Re: Arlington Storage Company, LLC, Seneca Lake Storage Facility Gallery 2 Expansion Project, Docket CP13-83, Expert Geologist Report

January 15, 2014

Earthjustice asked me to review the Arlington Storage Company LLC (Arlington) proposal to store compressed natural gas in bedded salt caverns in the Watkins Glen brine field adjacent to Seneca Lake in New York. The review included public documents obtained by Earthjustice and literature and data from other projects in the area. In addition, Earthjustice arranged for me to examine confidential material Arlington provided to the Federal Energy Regulatory Commission (FERC) for the development of its own Environmental Assessment (EA); comments about this part of the review are provided separately and confidentially to FERC. The following report is based solely on the publicly available documents and does not contain any information from the confidential materials provided by Arlington.

Exhibit 1

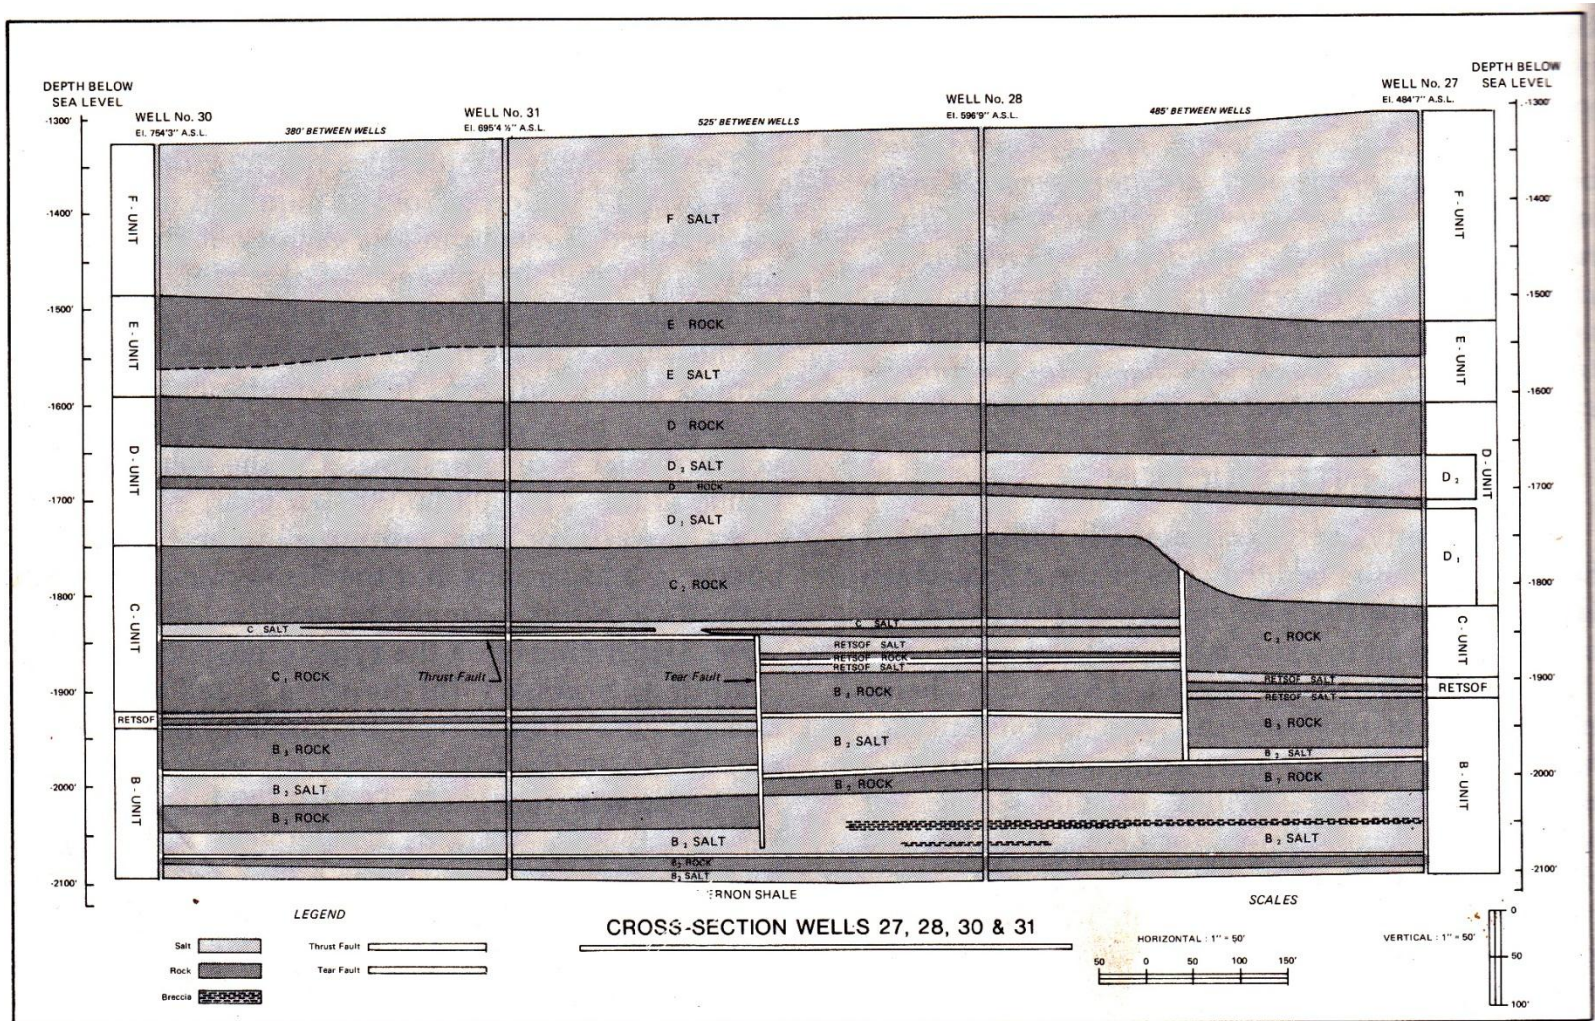
The four cross-section figures in the Jacoby 1969 paper illustrate the early history of this part of the brine field. All four wells were cored and geophysically logged as they were drilled, providing the stratigraphic and structural framework of each cross-section. His first cross-section (his Figure 1, attached as Exhibit 1) shows the pre-cavern geology interpreted from the logs and cores. Here, thrust faulting has pushed beds of salt and rock up and over one another, resulting in repeated sequences of several of the beds across the section.² The thrust fault noted in Exhibit 1 appears to continue to the east, though offset, within a Retsof salt bed sequence. In addition, faults oriented north-south, perpendicular to the figure and parallel to the west side of Seneca Lake and with vertical and horizontal offset are shown between Wells 31 and 28 and

² On Exhibit 1, the notation "Thrust Fault" between wells 30 and 31 points out one thrust fault, the fault that enabled the hydraulic fracture connection between Wells 30 and 31.

between 28 and 27.³ The fault shown between Well 31 (the easternmost cavern of Gallery 2) and Well 28 (the westernmost cavern of Gallery 1) is known as the Jacoby-Dellwig Fault,⁴ a major strike-slip tear fault with vertical displacement affecting the salt section as well as 1,200 feet of horizontal offset. The fault offsets and repeated section, or the encounter of the same sets of beds of rock and salt apparently stacked on top of one another in a wellbore and resulting from thrust faulting, shown on the cross-section were developed by correlating rock cores across this section as well as correlating geophysical logs from these wells and wells nearby (Jacoby, 1965, Jacoby and Dellwig, 1973). This work was a valuable contribution to Appalachian geology and the understanding of the complex role of faulting in the salt section. Moreover, the major strike-slip tear fault, together with the complex thrust faulting played a significant role in the determination of hydraulic fracturing direction and cavern development behavior in this part of the Watkins Glen brine field. Jacoby wrote as they observed a variety of hydraulic fracturing behavior: “Gradually, there emerged a theory of a double system of faults which controlled the direction of flow of our fracturing fluid.” (Jacoby, 1965) A map from the Jacoby and Dellwig 1973 paper (their Figure 3 attached as Exhibit 2) illustrates the orientation of the cross-section and the position of the wells with annotations from the same paper about hydraulic fracture connections and location of the Jacoby-Dellwig fault.

³ “Tear Fault” in Exhibit 1 points to the fault between Wells 31 and 28, there is another fault between Wells 28 and 27.

Exhibit 4

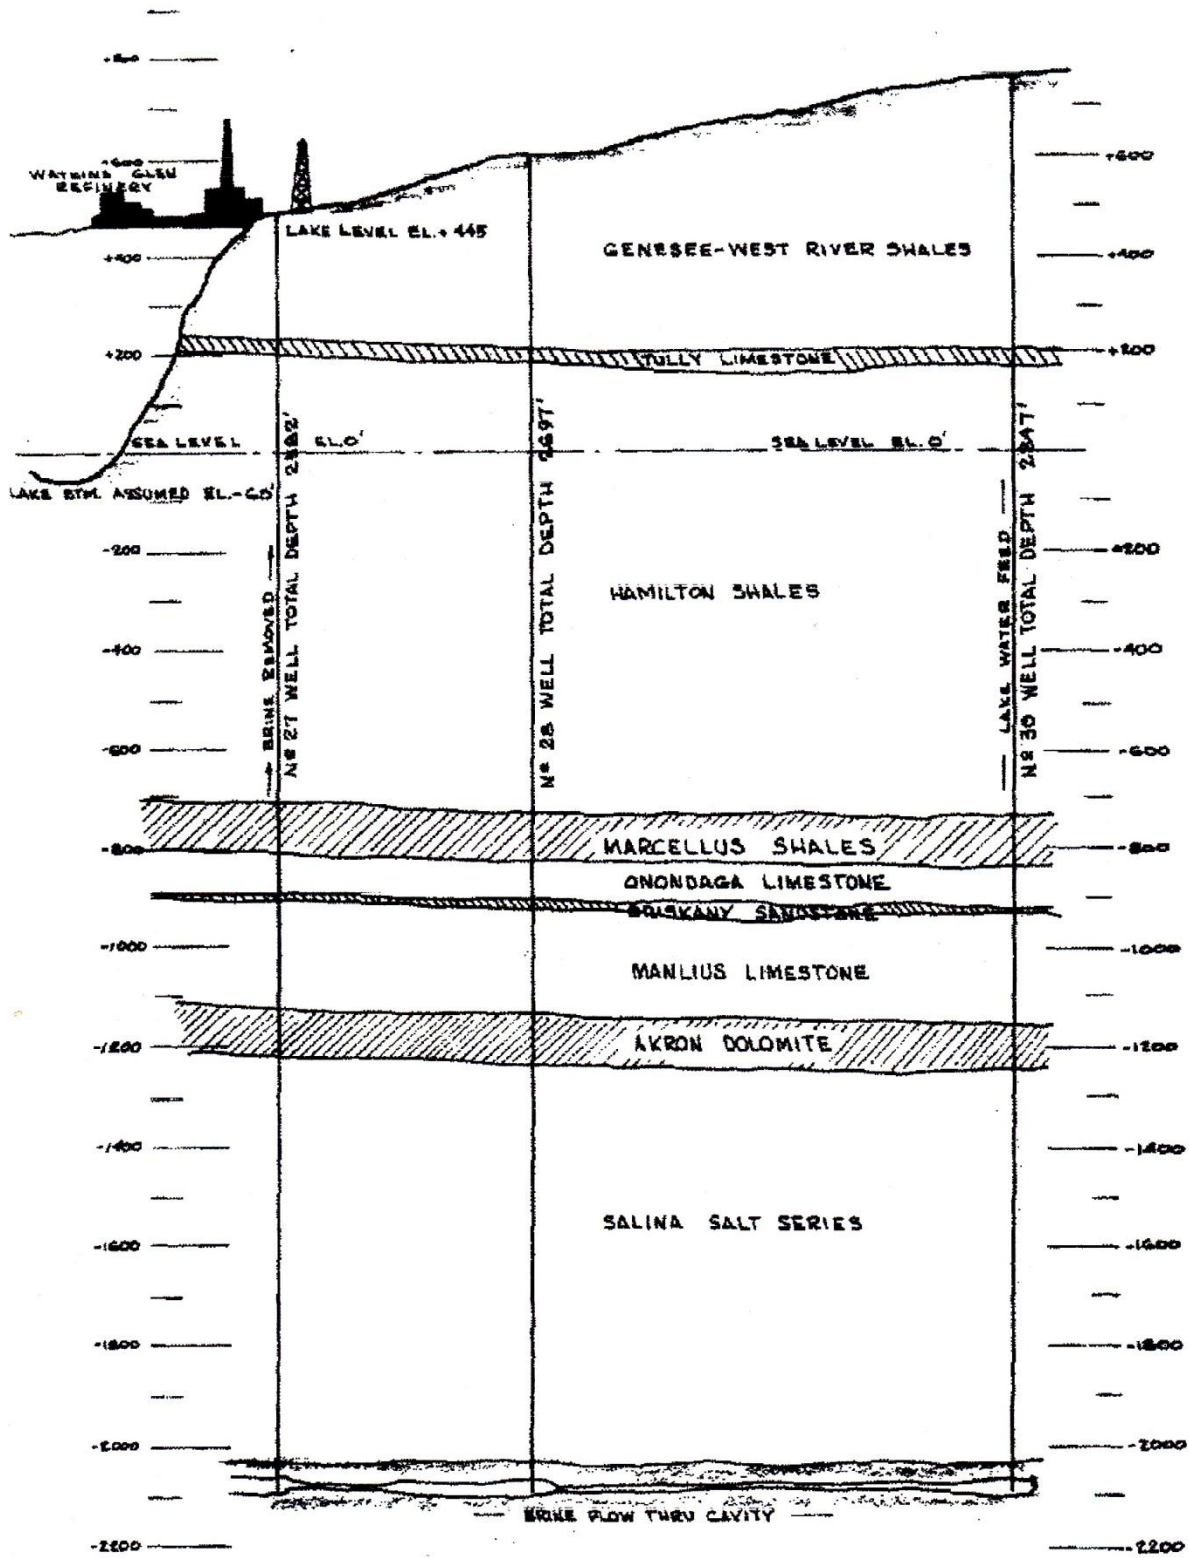
The next cross-section from the Jacoby 1969 paper (his Figure 2, attached as Exhibit 3) shows the situation in June of 1964. Initially, Well 30 and Well 31 were both hydraulically fractured at the lower B2 salt layer, but the process failed to connect the two wells by way of the lower B2 salt (see near-well fracture at wellbore depicted at the lower B2 of Well 31). “The connection between the two wells was finally completed in the **fault zone** in the **overthrust block** of B2 salt.” (Jacoby, 1969) (emphasis added). Jacoby wrote extensively about using an understanding of this thrust fault geology to design hydraulic fracture programs and to take advantage of a weakened fault zone path to a target well. And with regard to these wells, he notes: “At the points on the cross-section where faulting has been confirmed, fault zones several feet in thickness are present.” (Jacoby, 1969) Following fracturing, communication was established between Wells 30 and 31 and Gallery 2 solutioning development began. The cross-section of Jacoby’s Figure 2 shows that the two connected caverns were being used for LPG

storage in 1964 as shown by the propane legend symbol in the upper part of Cavern 31 and at the top of Cavern 30. The vertical extent of the hydraulically fractured fault zone connecting Cavern 30 to Cavern 31 is discussed only qualitatively in the paper, but the areal extent of the hydraulic fracture connection must be significant since publicly available mapping⁵ shows Well 45 to be offset from a straight line connecting Wells 30 and 31, and it intercepts the fractured fault zone connection and will be used in the Arlington plan as a monitor well. While on the subject of the hydraulically fractured connection between Wells 30 and 31, there is a cross-section in another Jacoby paper that shows a connection between Well 30, Well 27, and Well 28 (Jacoby, 1961, Figure 2 attached as Exhibit 4). That paper is a discussion of the brine mining process and the wells are not discussed specifically. If there is or was a connection, that would connect Gallery 2 to Gallery 1, and this would be a significant concern. Arlington must have all the original records, and it could provide that information from the original source to resolve this question. The connection by way of a fault zone that affects both Well 30 and Well 31 and beyond, and perhaps way beyond, is not discussed in the public Arlington documents that I have reviewed.

Exhibit 5

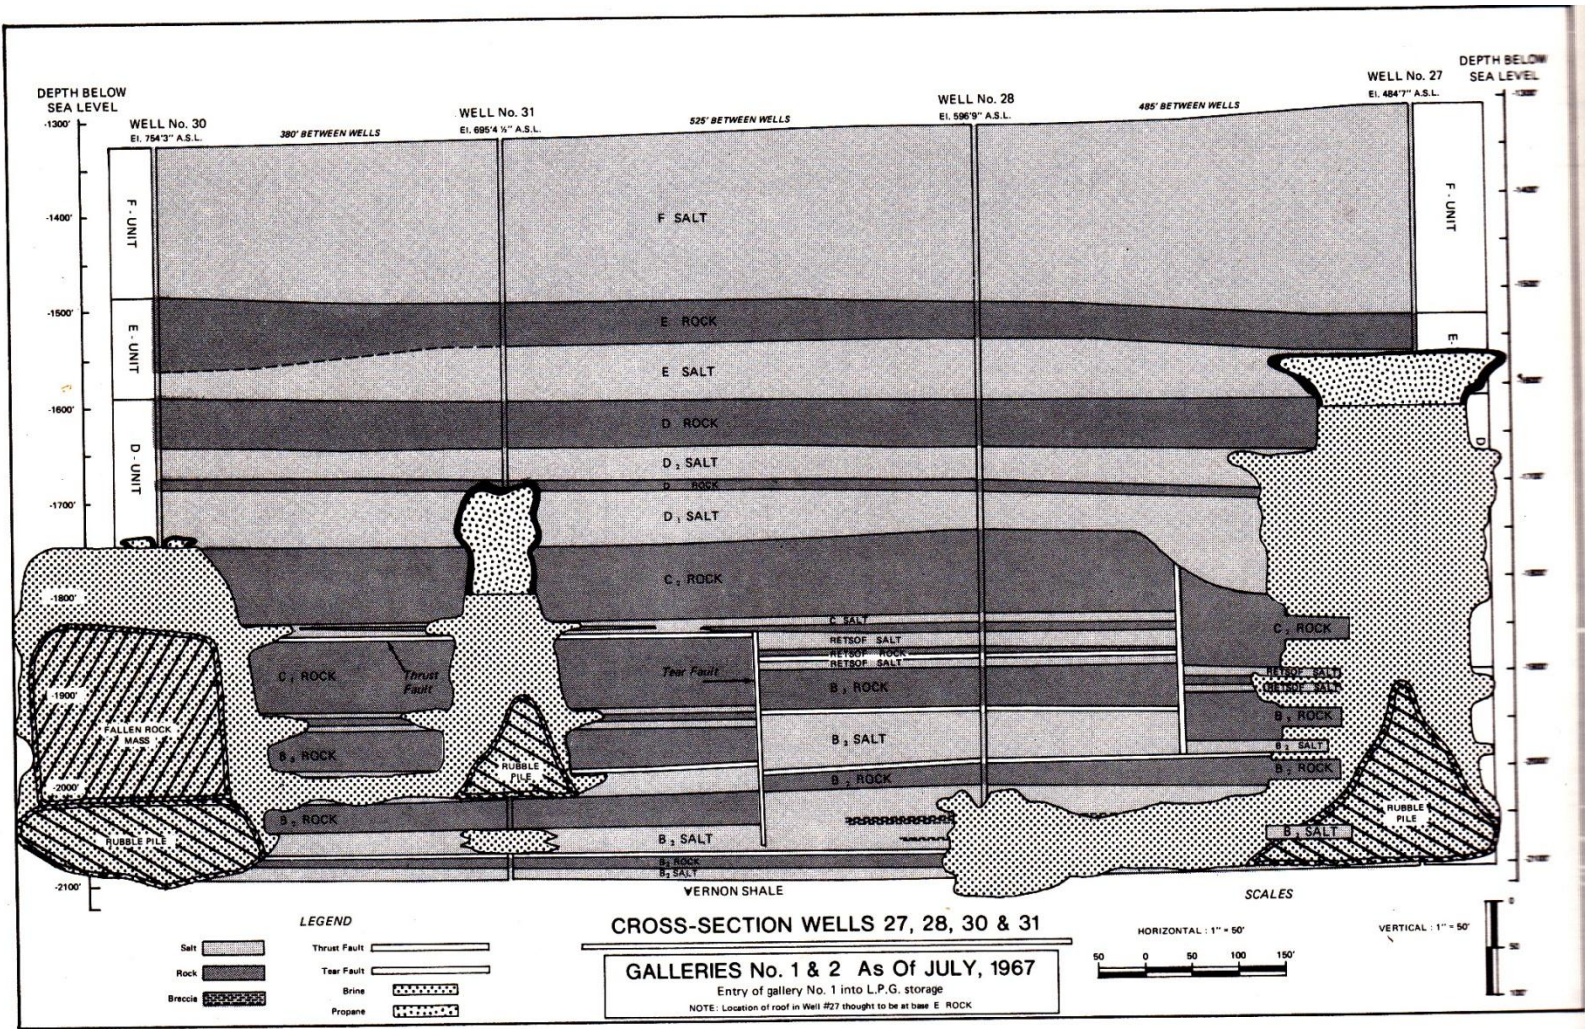
By July of 1967, the date of the next cross-section, both Gallery 2 (Cavern 30 connected to Cavern 31) and Gallery 1 (Cavern 27 connected to Cavern 28) were being used for LPG storage. (Jacoby Figure 3, attached as Exhibit 5). By this time, the caverns had expanded, leaching salt and accumulating rubble where interbedded unsupported rock layers had fallen. Jacoby depicts the four caverns filled with a combination of brine, propane, and rubble. In perhaps the most striking revelation of this review, there is a large intact block in Cavern 30 with a suspicious jig-saw puzzle fit to the cavern outline above and noted as “Fallen Rock Mass” on the cross-section. That is, Cavern 30’s roof failed, and the rock fall was dramatic. This is explained by Jacoby as a lesson to use saturated brine in cycling product out of the caverns:

Unless saturated brine is used continually in recycling the product, there is distinct possibility of undermining **fault blocks**. Illustrated in (Jacoby) Figure 3 is a large block of rock calculated to weigh over **400,000 tons** which **fell from the roof** even with the use of saturated brine.

(Jacoby, 1969) (emphasis added). Perhaps anticipating, even then, an attempt to discredit this cavern roof rock fall event, he went on to say: “This portion of the cavity was outlined by using sonar surveying equipment.” The parallel between the fault block cavern roof failure in Cavern 30 and the roof collapse in Cavern 58 is obvious. It is clear that researchers working on caverns in the Watkins Glen brine field have encountered cavern roof failures and attributed these failures to fault situations. It is essential that cavern roof failure in the Watkins Glen brine field be recognized.

Exhibit 6

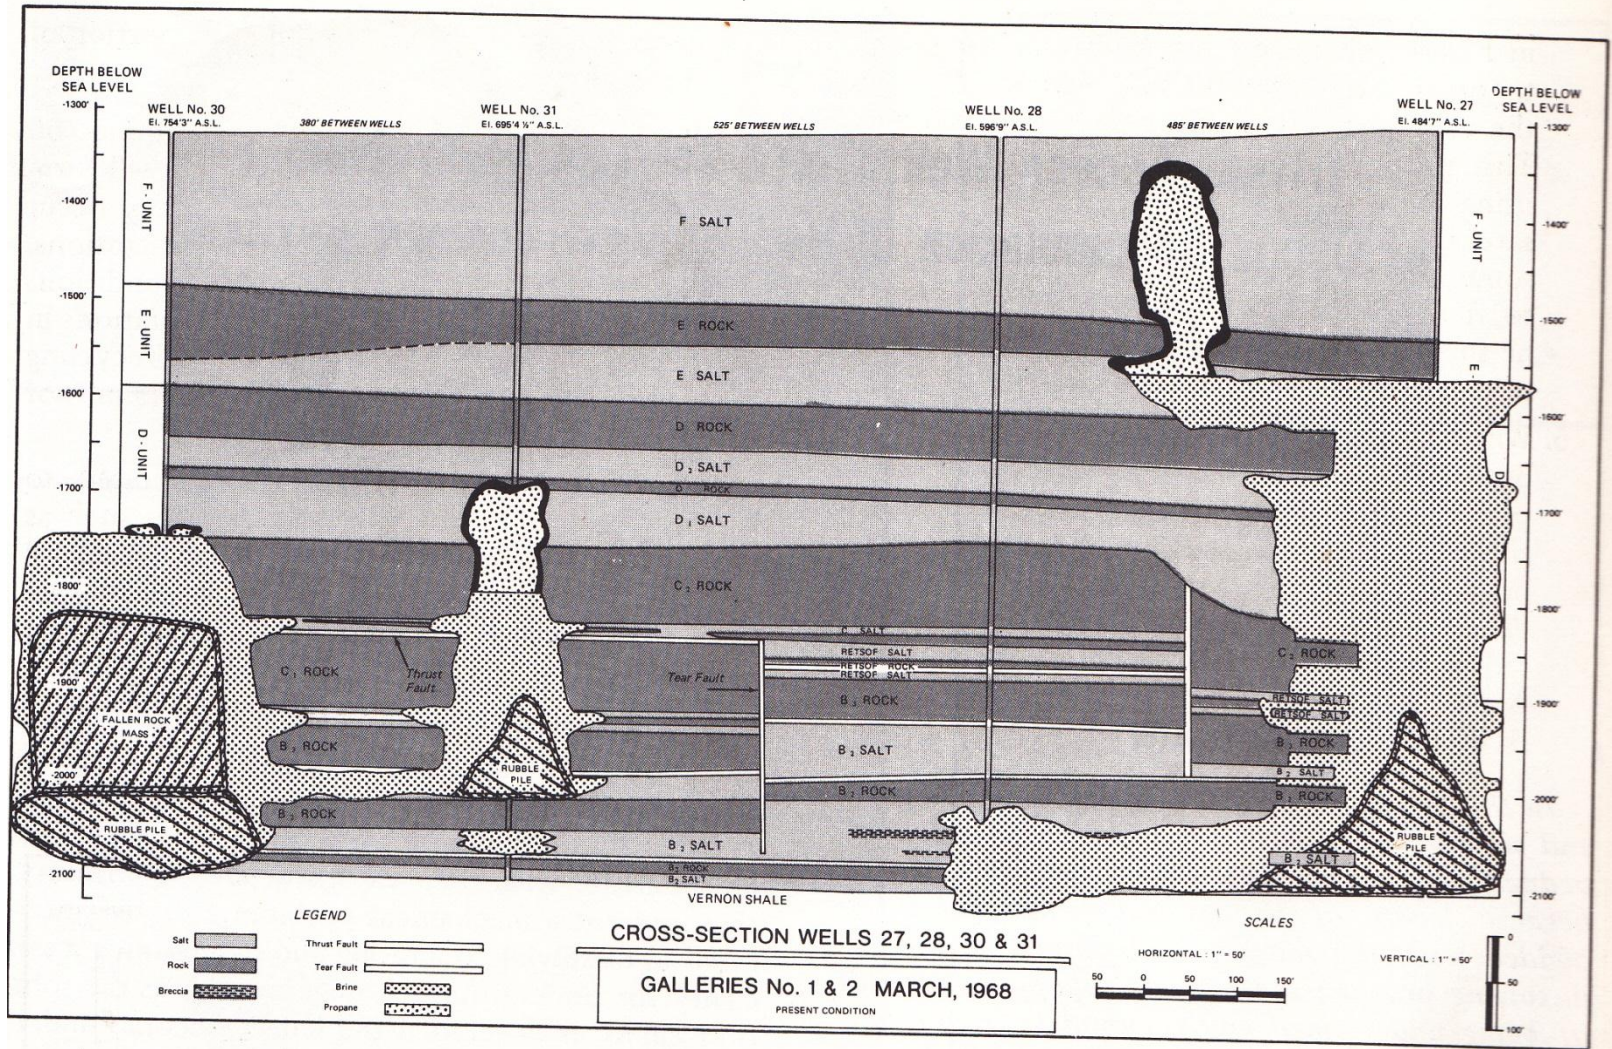
The final figure of the Jacoby paper describing the development of Gallery 2, and Gallery 1 as well, shows the condition of the caverns in March, 1968 (attached as Exhibit 6). By this time, there was a small amount of propane at the top of Cavern 30, propane at the top of Cavern 31, and propane in a part of Cavern 27 offset from that well—and on its way to becoming the subject of another Jacoby paper, "Recovery of Entrapped Hydrocarbons" (Jacoby, 1973), where he described the effort to drill an interceptor well to recover product in a part of Cavern 27 that had developed unintentionally and no longer was accessible by the original well. The directionally drilled interceptor well is Well 46 and the paper shows the cavern development significantly displaced west of the original Well 27.
